UNITED STATES PATENT AND TRADEMARK OFFICE

APPLICATION NO.	FILING DATE	FIRST NAMED INVENTOR	ATTORNEY DOCKET NO.	CONFIRMATION NO.
10/773,260	02/09/2004	Pierre Grasset	14612	7149
293	7590	05/04/2005	EXAMINER	
Ralph A. Dowell of DOWELL & DOWELL P.C. 2111 Eisenhower Ave. Suite 406 Alexandria, VA 22314			MENDOZA, MICHAEL G	
			ART UNIT	PAPER NUMBER
			3731

Office Action Summary	Application No.	Applicant(s)	
	10/773,260	GRASSET, PIERRE	
	Examiner	Art Unit	
	Michael G. Mendoza	3731

DETAILED ACTION

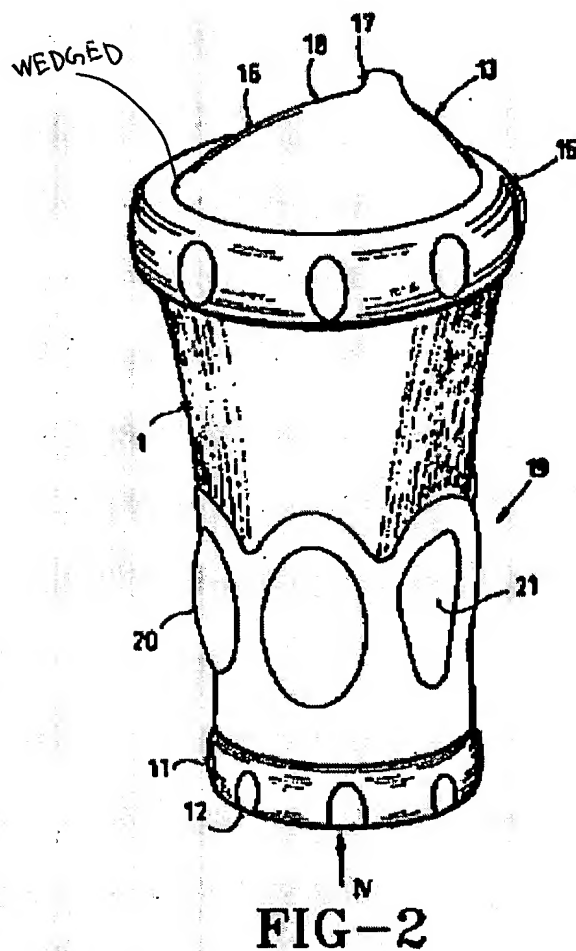
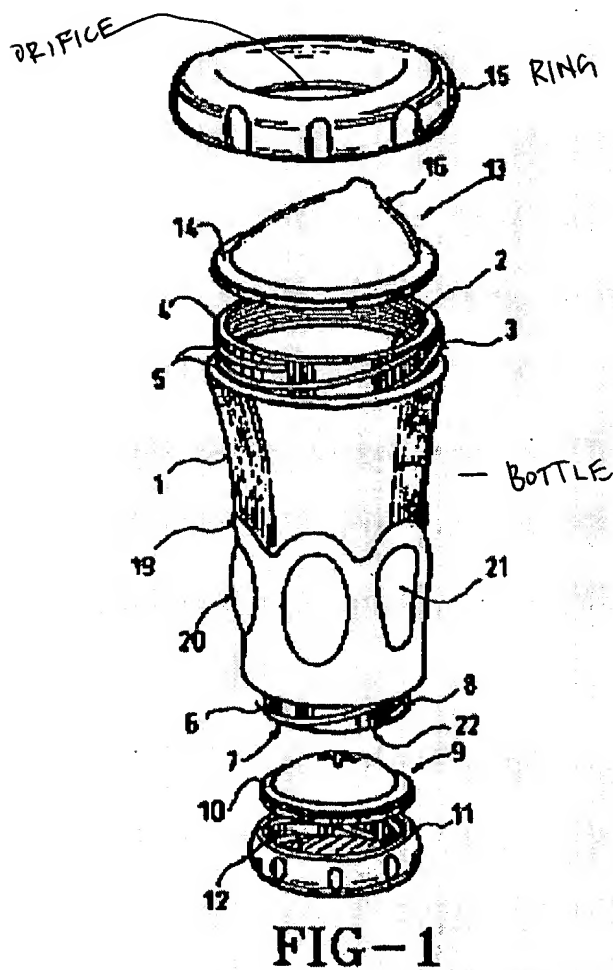
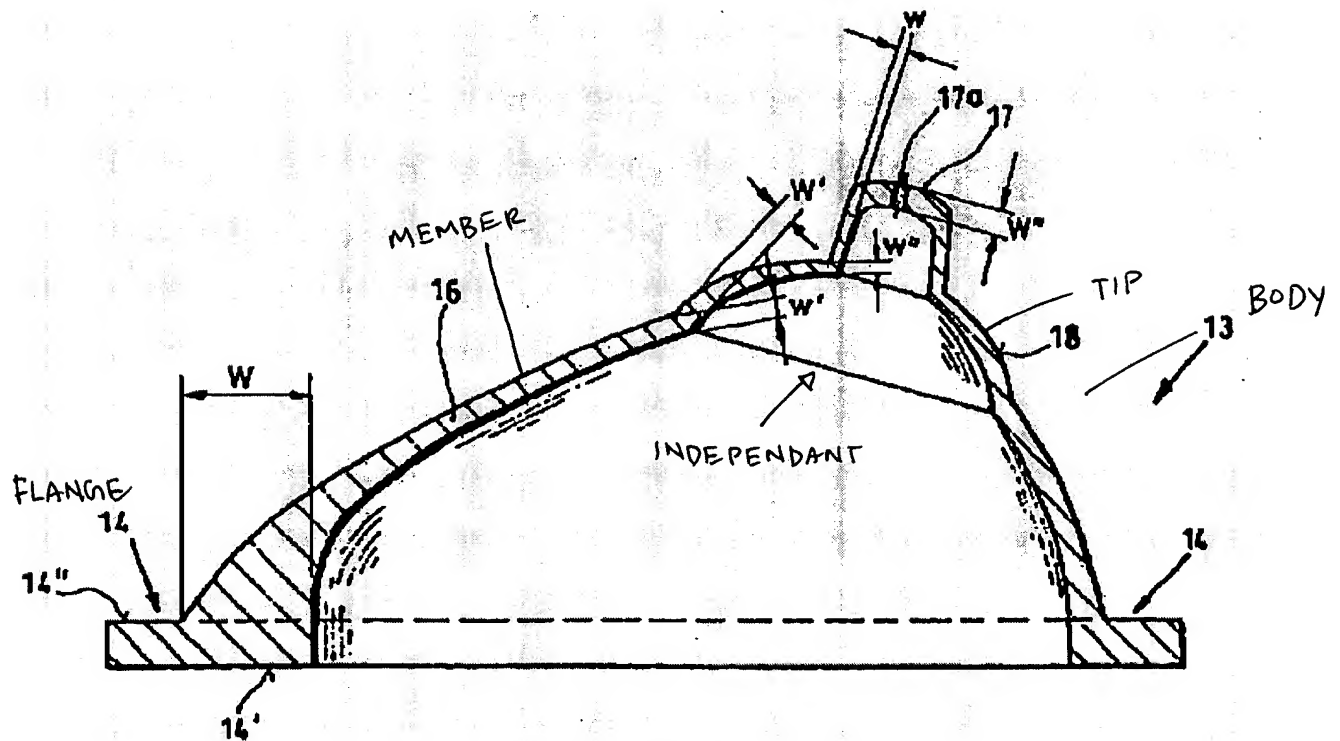
6. Kerns et al. teaches a nursery care article, in particular a feeding bottle or comforter, comprising a body 13, a tip for suction 18, a member on which the infant's lips abut 16; wherein the hardness of the member on which the lips abut is clearly greater than the hardness of the tip (col. 13, lines 35-39); wherein the tip and the member on which the lips abut belong to a teat of the bottle; wherein the member on which the lips abut and the tip are mutually independent, at least in translation along a principal axis of the tip; a ring 15 adapted to be connected on the body, the member on which the lips abut being integral with the ring, while the tip belongs to a teat of the bottle, which is adapted to be removably fixed, by wedging, between opposite surfaces of the ring and the body (fig. 1); wherein the member on which the lips abut defines, opposite the ring, and orifice for the passage of the tip (figs. 1 & 2); wherein the teat

comprise the tip, a flange 14 for wedging between the ring and the body, as well as a zone for connection between the tip and the flange, whose shape is adapted to facilitate the movement of the tip, along its principal axis, with respect to the flange; wherein the member on which the lips abut being integral with the body, while the tip is extended by a flange for fixation on the body, an orifice for passage of the tip being made in the member on which the lips abut.
